Addendum 57 – UN Regulation No. 58

Revision 3 - Amendment 2

Supplement 2 to the 03 series of amendments – Date of entry into force: 25 September 2020

Uniform provisions concerning the approval of:

Figure 1

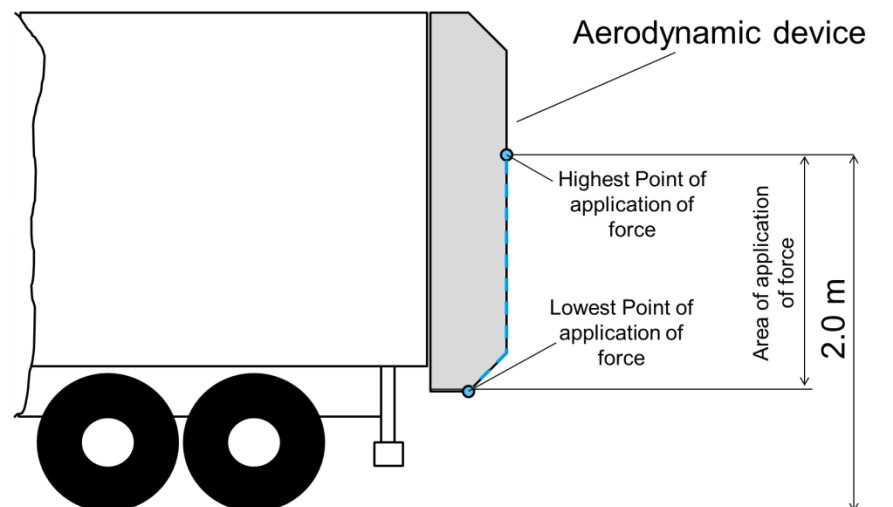
- 5.1.1. A force shall be applied parallel to the longitudinal axis of the vehicle via a surface not more than 250 mm in height and 200 mm wide with a radius of curvature of 5 ± 1 mm at the vertical edges or an adaptor. The surface or adaptor shall not be rigidly fixed to the aerodynamic device and shall be articulated in all directions. When the test is carried out on a vehicle the height of the centre of the surface or adaptor shall be defined by the manufacturer in an area between the lowest edge of the aerodynamic device and a point no more than 2.0 meters above the ground in vehicle-mounted condition (see figure 1). This point is to be defined on a laden vehicle with the technically permissible maximum laden mass.

Figure 3

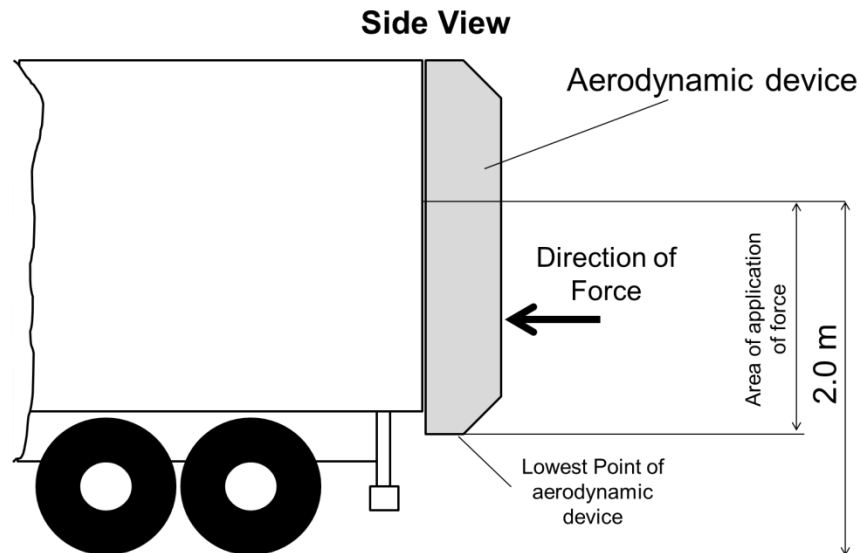
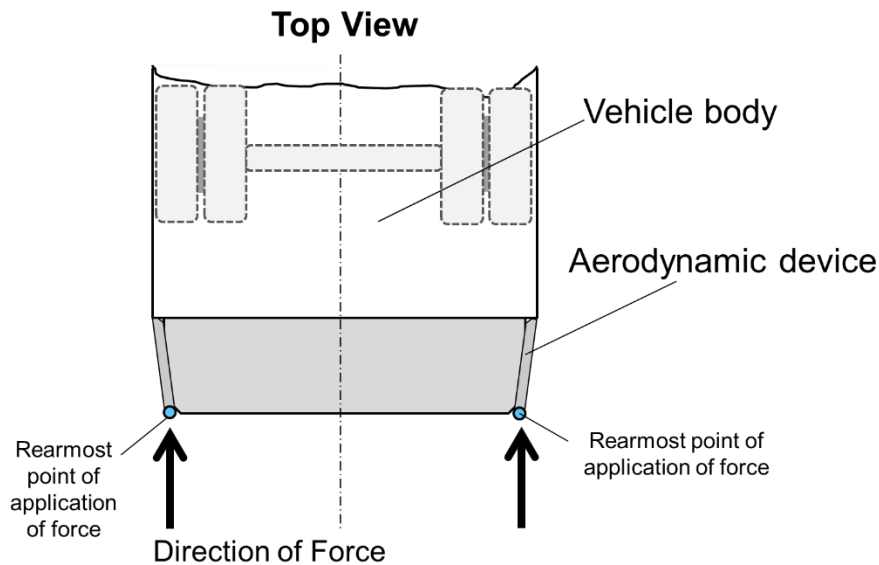
5.1.2. A horizontal force of maximum $4000 \text{ N} \pm 400 \text{ N}$ shall be applied consecutively to two points situated symmetrically about the centre line of the vehicle or the centre line of the device on the rearmost outer edge of the aerodynamic device in completely unfolded or not retracted condition (see figure 3). The order in which the forces are applied may be specified by the manufacturer.

Figure 4

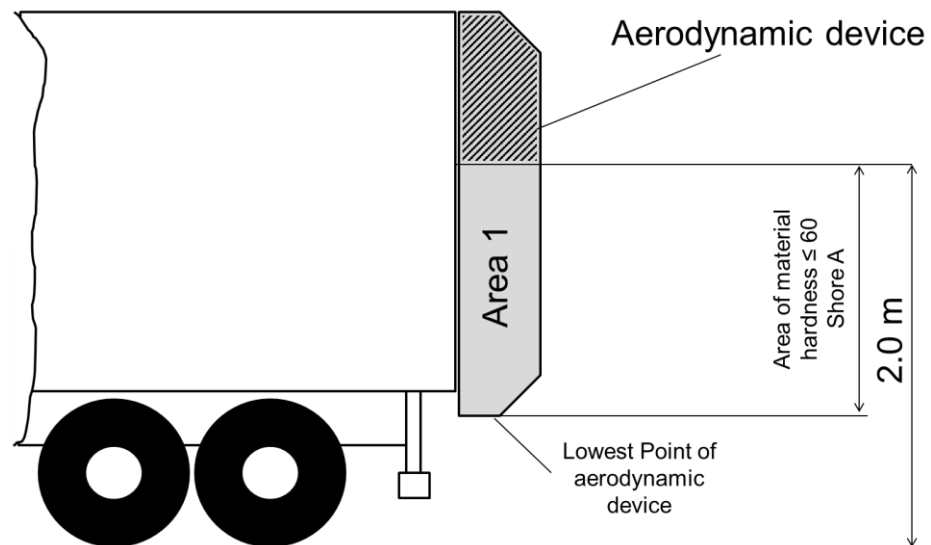
- 6.2. Notwithstanding the provisions in paragraph 5.1., 5.1.1., 5.1.2. and 6.1. the application of forces shall not be conducted if the aerodynamic device is made of a material of hardness not exceeding 60 shore A in the area 1 regarding figure 4. Components (fastenings, hinges, actuators, springs, cables, lamps, etc.) used to install the aerodynamic device on the body of the vehicle or that are mounted on the aerodynamic device are exempted from these provisions.
